Attached Garage

The following items are conditions for permit issuance and strict compliance is mandatory.

Figure 1. Recommended construction details for APA portal frame bracing without hold-downs

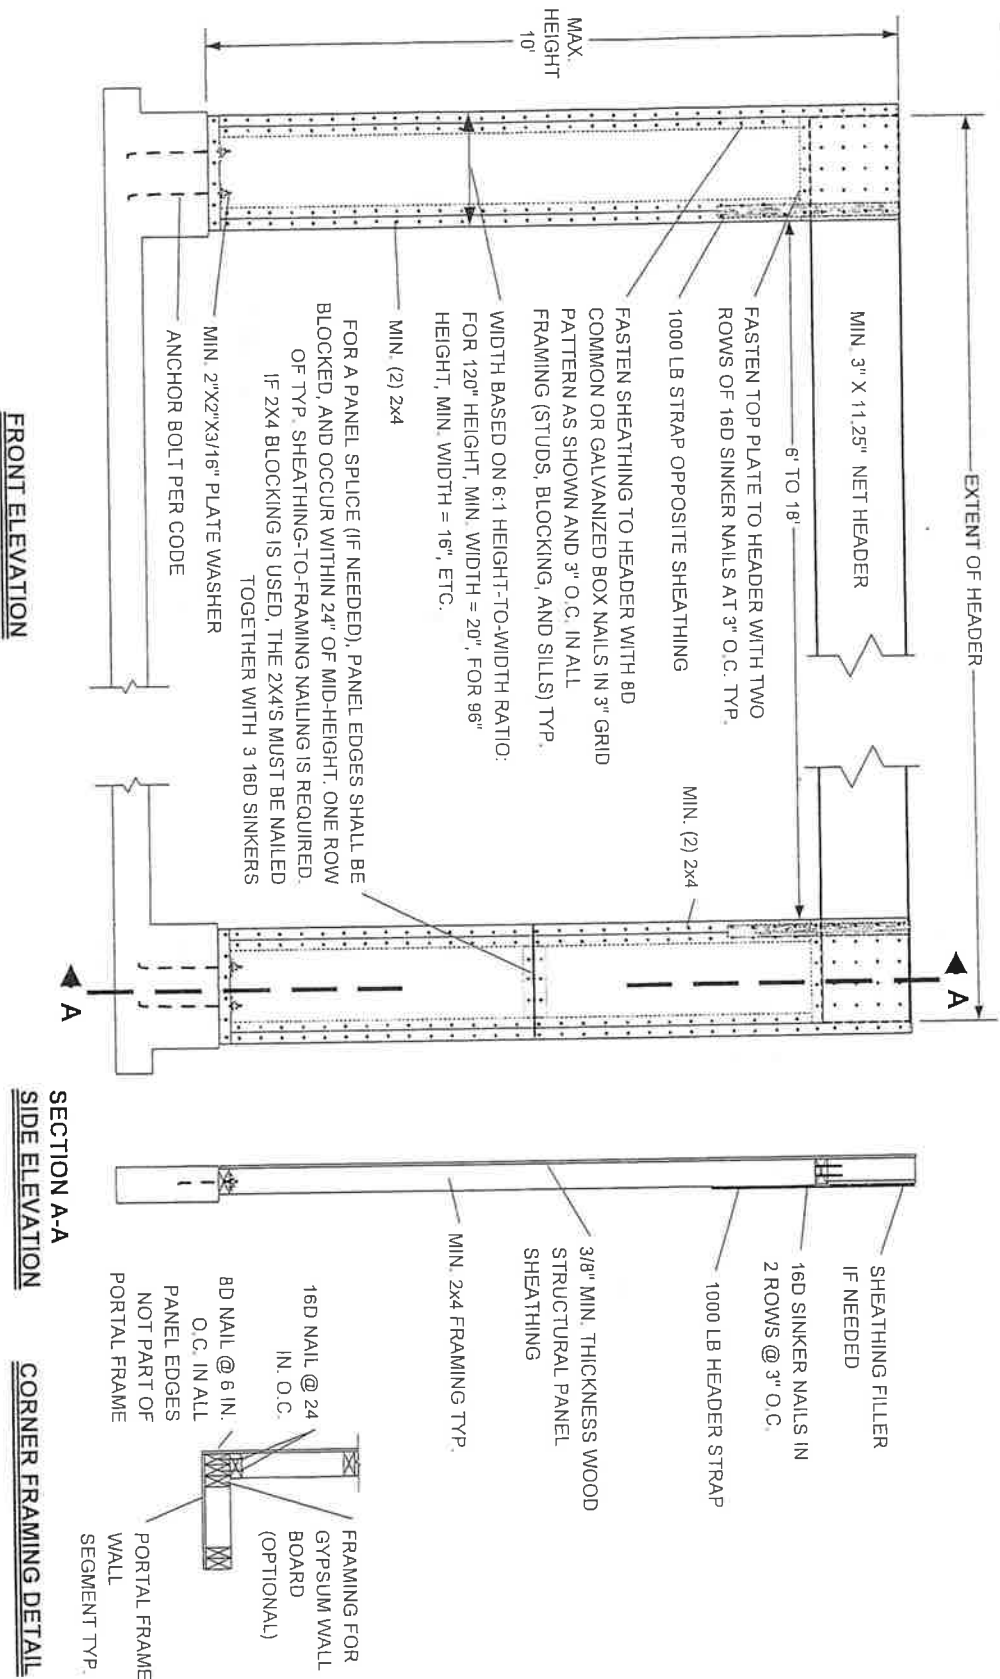
BRACED WALL PANEL
